# Nomad

## SERVICE BULLETIN

### ICE PROTECTION SYSTEMS – REMOVAL OF WING, TAILPLANE AND FIN BOOTS AND RELATED SYSTEMS

Figure 2 De-Ice Timer Unit

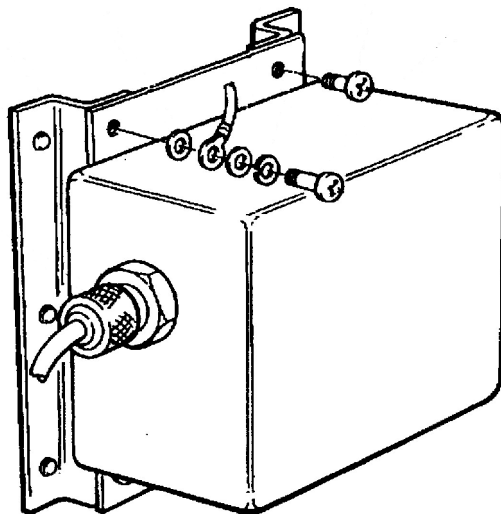
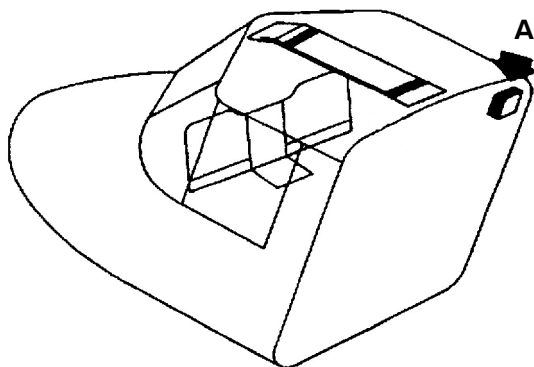
- (1) Cabin
  - (a) Remove Airframe De-Ice Timer (Ref Fig 2).
  - (b) Cap and stow connector onto adjacent wiring in accordance with accepted aircraft practice.

Figure 3 View Showing Stall Breaker Strip Location

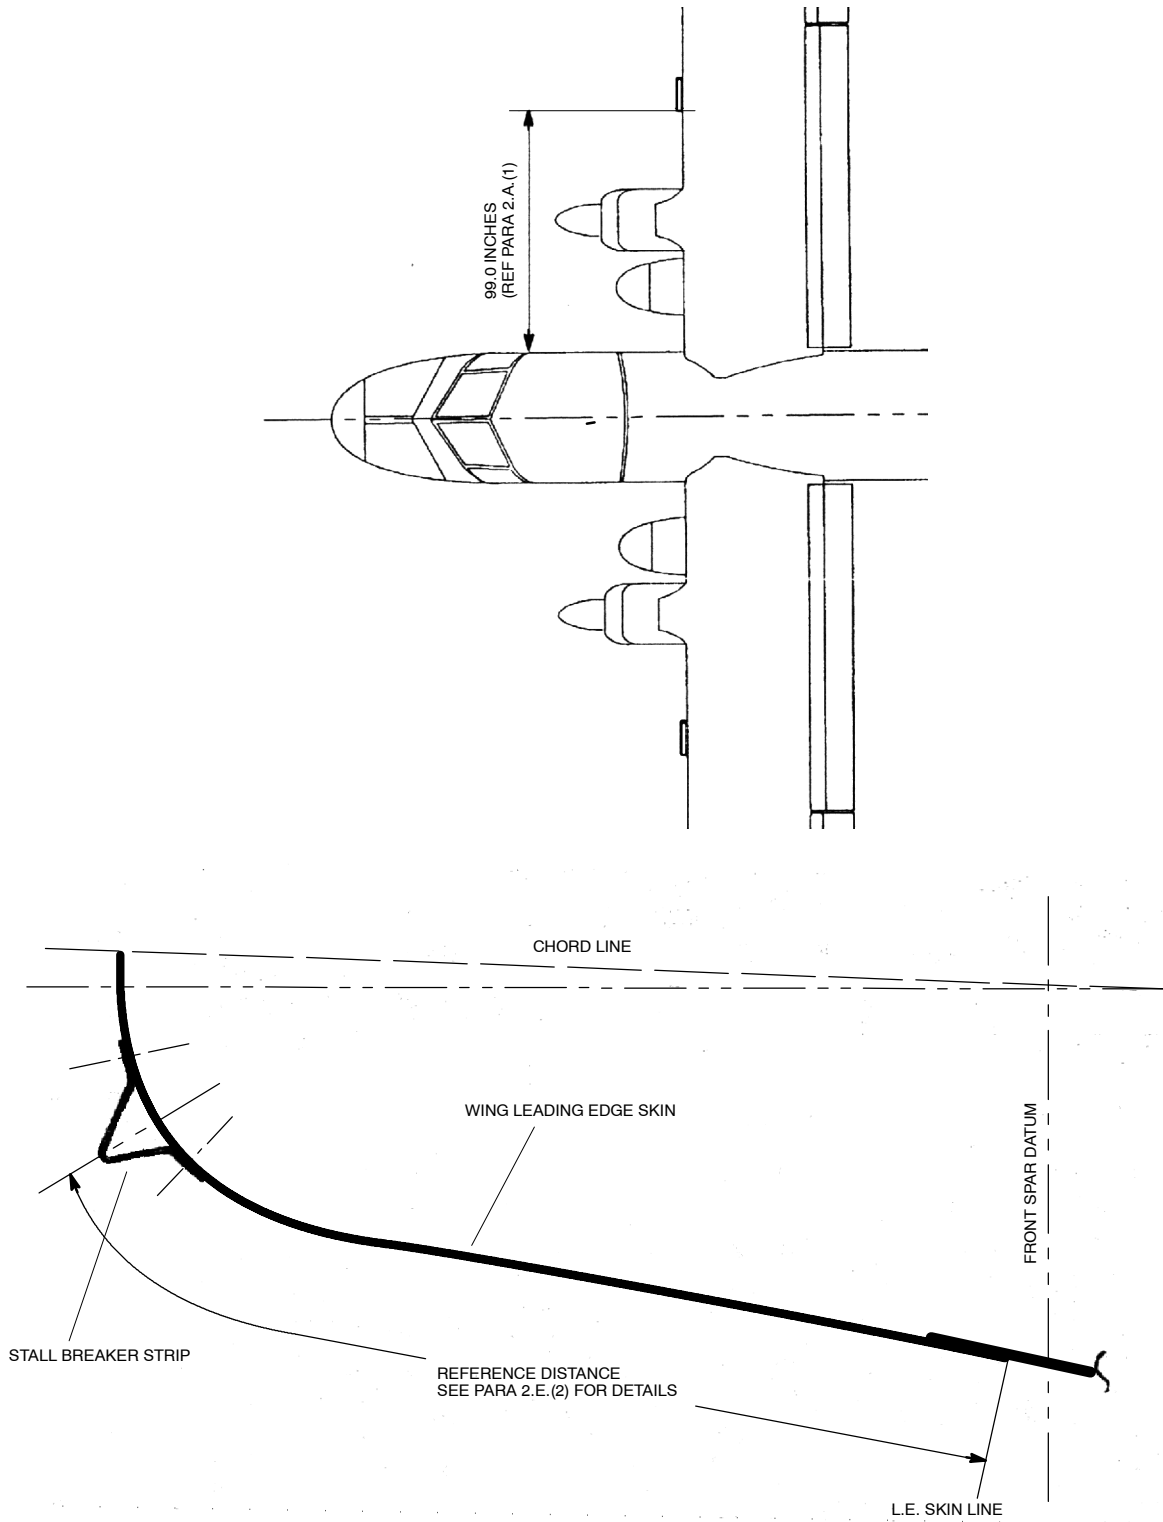
- (1) Figures 3 and 4 are provided for reference. It is suggested that prior to the removal of the De-Icing boots from the wing leading edge, measurements are taken of the position of the existing rubber Stall Breaker Strips.

- (2) For reference the inboard edge of the Stall Breaker Strip is at wsta 99.0 in (Ref Fig 3) and the position of the apex of the Strip on the leading edge of the wing is 10.4 in forward of the leading edge skin line (Ref Fig 3).

- (3) If on removal of Boots it is found that two rows of filled rivet holes exist (on each wing leading edge) such that metal Stall Breaker Strips may have originally been fitted, a new Stall Breaker Strip (Part Number 1M/N-20-609/10 as appropriate) should be offered up to each wing leading edge in a position to correspond to the pre-existing rivet holes and attached with double-sided adhesive tape.  
If no pre-existing holes are present, then a new Stall Breaker Strip (Part Number 1M/N-20-609/10, as appropriate) should be offered up to each wing leading edge in a position as near as possible to the measurements taken in Para (1) above, and attached with double-sided adhesive tape. The object being to position the apex of the new metal Stall Breaker Strip as near as possible to the position of the apex of the original rubber Stall Breaker Strip.

Figure 4 Detail of Stall Breaker Strip Attachment (RH Wing Shown, LH Similar)

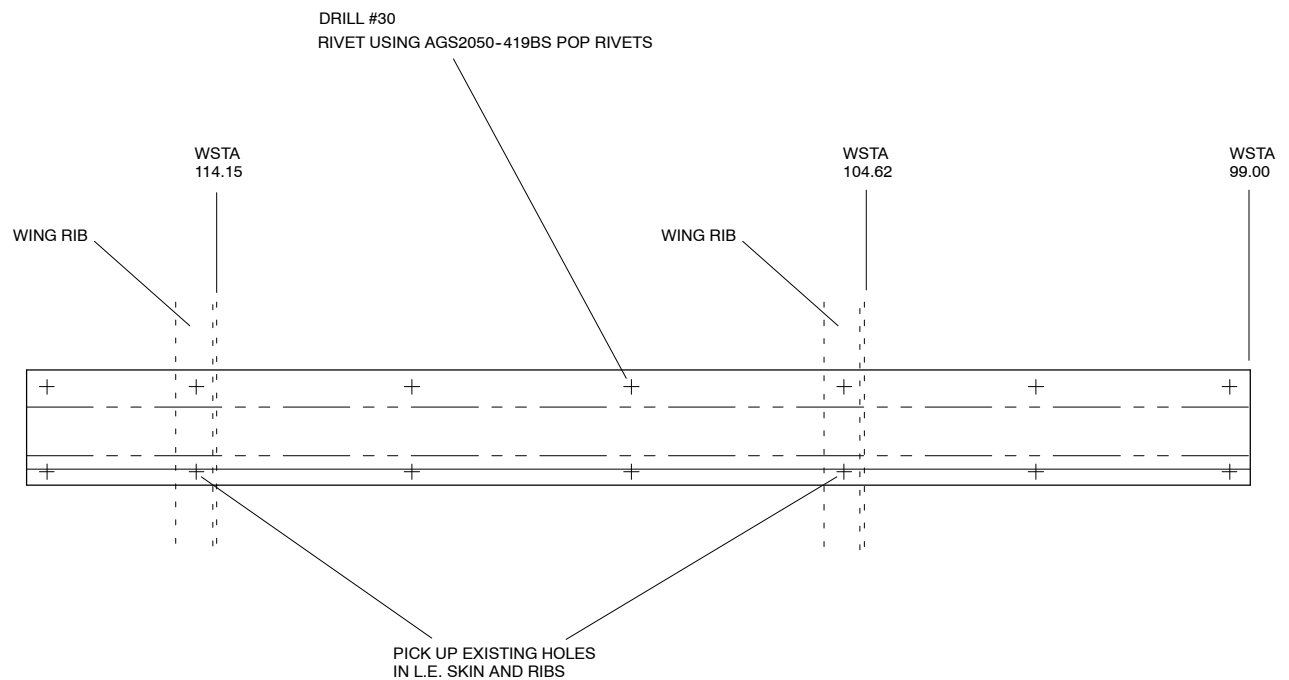
- (5) On satisfactory completion of the above tests the Stall Breaker Strip should be finally fastened to the wing leading edge skin as follows (Ref Fig 4):
  - (a) Locate Stall Breaker Strip in final position.
  - (b) At wing rib positions (wstas 104.62 and 114.15) drill out existing rivets and back-drill (#30) into Stall Breaker Strip.
  - (c) If original holes exist, back drill (#30) Stall Breaker Strip from rest of holes in wing leading edge; else drill new holes as shown in Figure 4.
  - (d) Deburr all holes. Wet assemble and rivet in position.
  - (e) Touch-up prime and paint as required.
